Docket Item # 3  
BAR CASE #2008-0181

BAR Meeting  
December 3, 2008

**ISSUE:** Signage  
**APPLICANT:** Tim Traywick  
**LOCATION:** 821 South Washington Street  
**ZONE:** CRMU/L, Commercial

Figure 1: Proposed Sign

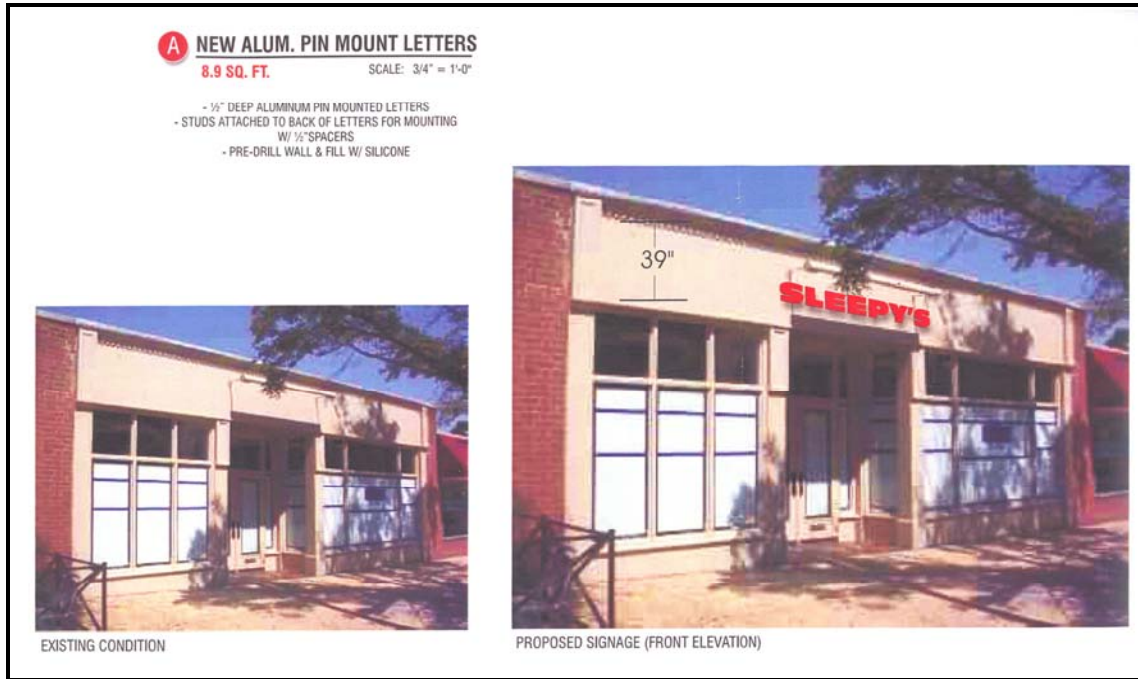
The applicant is requesting approval of a Certificate of Appropriateness for a sign, "SLEEPY'S", at 821 South Washington Street. The individual pin mounted red letters will be located above the entrance to the store. The "SLEEPY'S" sign will measure 8' 11" by 1' and will be illuminated by an existing light fixture.

C-1 Wall letters / signs must comply with USBC [H103-H111] Please indicate the method to be used for anchoring the letters to the wall.
